Bulletin

MODEL : BENTLEY MARK VI

MODIFICATION.

- a) Rear Axle Retaining Bolts.
- b) Rear Brakes - Equal wear Linkage.

FIG. 1.

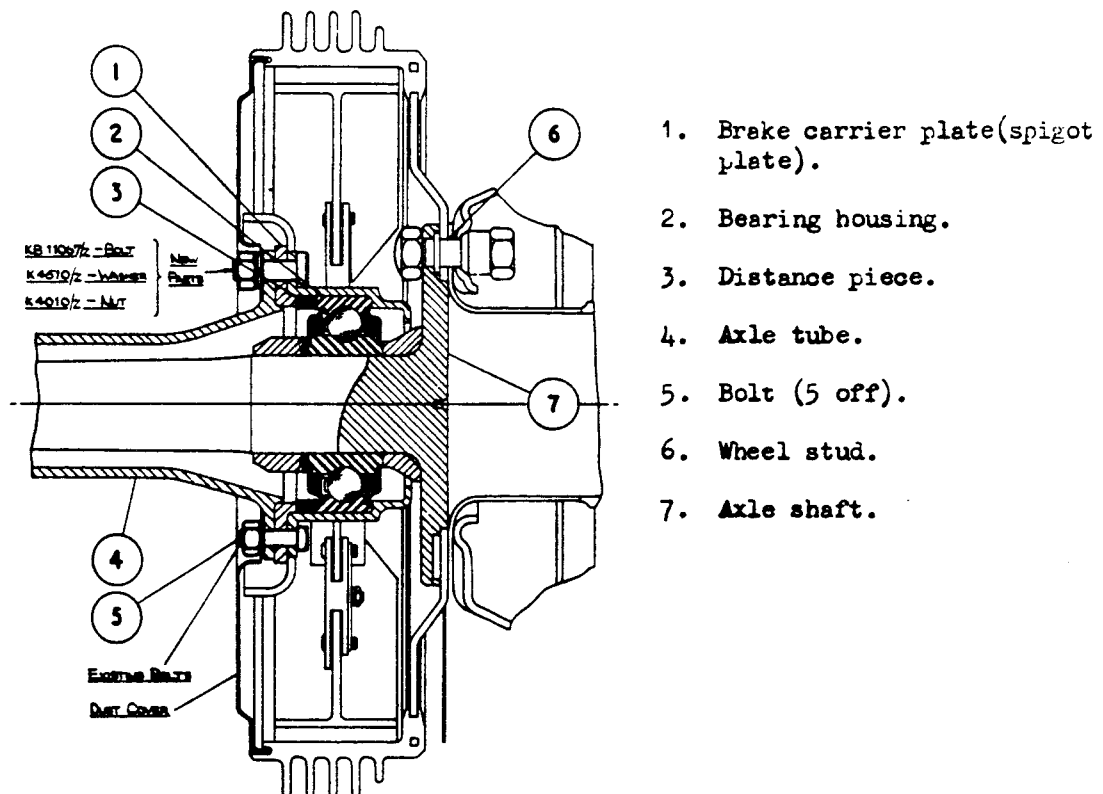
It has been decided to fit 3/8" diameter bolts as shown on Fig.1, in place of the existing 5/16" diameter bolts (5) which retain the rear axle shaft bearing housing (2) and the brake carrier plate (1) to the axle tube. It has also been decided that opportunity should be taken to reverse the equal wear brake linkage of the rear brakes and fit the stiffened linkage which consists of a new push rod and jaw.

- (iii) Unscrew the five 5/16" B.S.F. nuts from the bolts (5 Fig.1) lying inside the recess in the dust cover at the rear of the brake carrier plate and gently draw out all the bolts which retain the axle shaft bearing housing (2) and the brake carrier plate (1) to the axle tube (4).

FIG. 2.

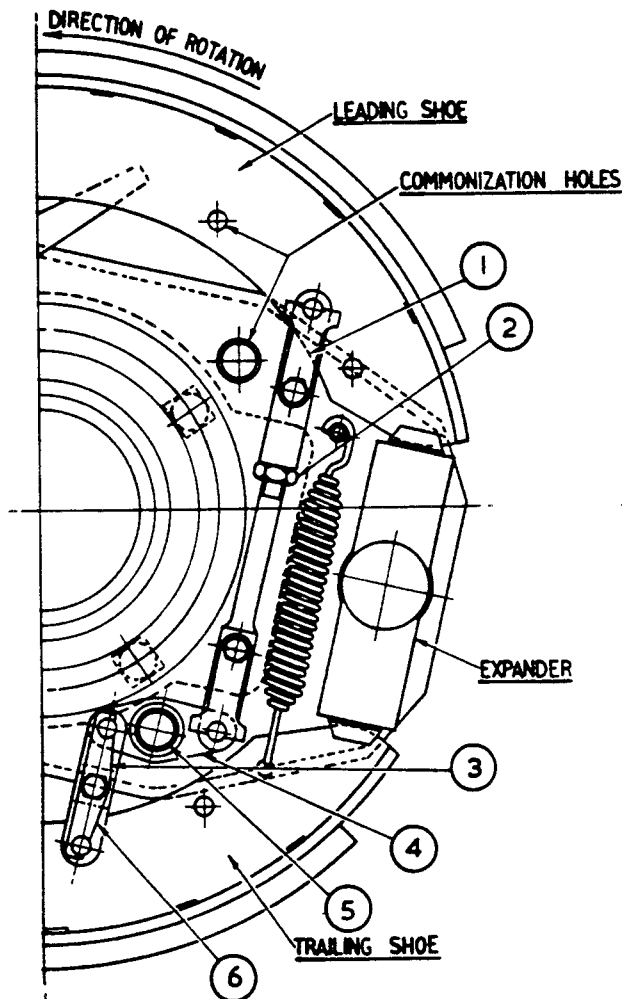
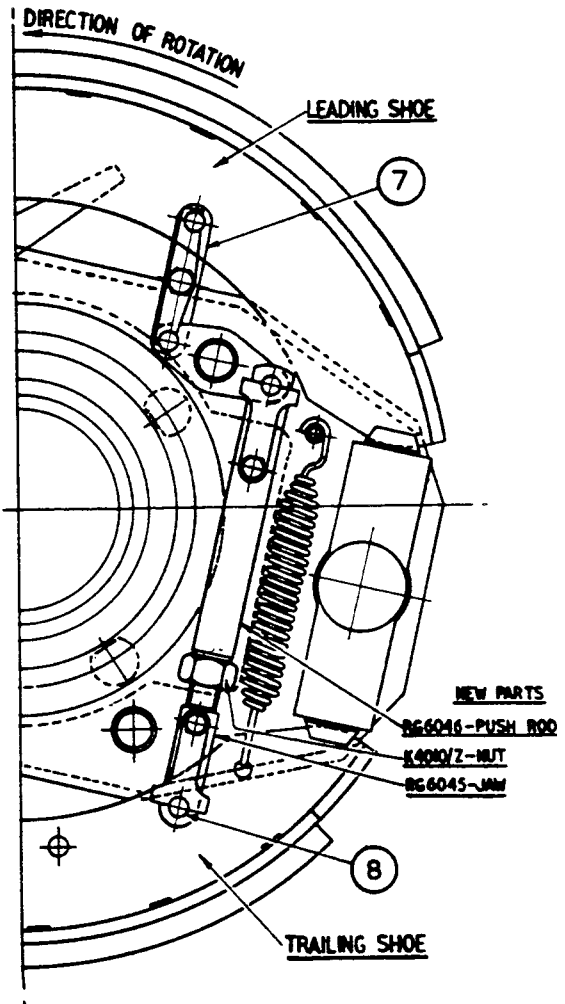
Although some cars will already have the unstiffened linkage reversed and others will have the stiffened linkage, it is desired that all cars should be brought to the full modified standard as soon as possible. The decision to reverse the brake linkage and fit the stiffened type is in order to eliminate the possibility of the rear brakes developing a jaming action (spragging), due to the trailing shoes pivoting about the inter shoes equal wear linkage instead of about the adjuster end of the shoe. A modification has been introduced, moving the point of attachment of the linkage to the trailing shoe nearer the adjuster. This is done by simply reversing the linkage and the central pivot of the linkage, so that the shorter of the two links is now attached to the leading shoe instead of to the trailing shoe as was previously the case. (See Fig.2).

- (ii) Unscrew the two setscrews retaining the locking plates (1 & 6 fig.2) on the inter shoe linkage nearest each shoe and pull out the pins holding the links to the shoes and withdraw the complete linkage away from its pivot (5). Do not disturb the setting of the push rod by turning the jaw relative to the rod. It is advisable before removing the linkage, to check the locknut (2) on the push rod for tightness.
- (iii) With a 7/16" (B.S.F.) cranked ring spanner, remove the locknut, the Grover and plain washer from the back of the pivot (5) and transfer the pivot from its position just above the lower or trailing shoe to the existing hole in a similar position just below the upper or leading shoe. (See "Modified" Drawing Fig.2).

FIG. 1.

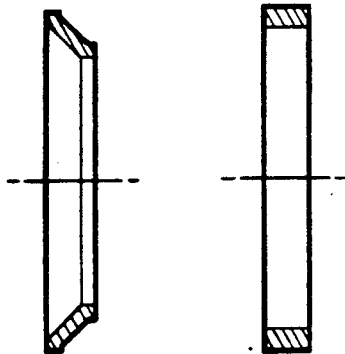
In addition to carrying out the modifications as detailed in Bentley Service Bulletin No: BB-73 (Section L), it has also been decided to reduce the nip on the outer race of the ball bearing on the axle shaft to zero by reducing the width of the distance (adjusting) piece, (3 Fig.1 of Bulletin BB-73) from 0.002" to 0.003" (0.050 m/m to 0.076 m/m) whatever the width of the distance piece may be found to be.

Fig. 1 (below) is a section through the distance piece fitted to the ball bearing assembly of the axle shafts for chassis series 'AK', 'AJ', 'BH' and 'BG' and Fig. 2 is a cross section through the distance piece fitted to the ball bearing assembly of the axle shafts for series 'CF', 'CD' and onwards.

- (i) After the removal of an axle shaft as described in Bulletin No: BB-73, remove the distance piece from the ball bearing housing which is a free fit.
- (ii) Carefully measure the width of the distance piece and reduce the width by machining 0.002" to 0.003". The distance piece is made of mild steel. In the unlikely event of machining facilities not being available, then it will have to be carefully reduced by hand, keeping the faces parallel.
- (iii) Repeat for the opposite side.
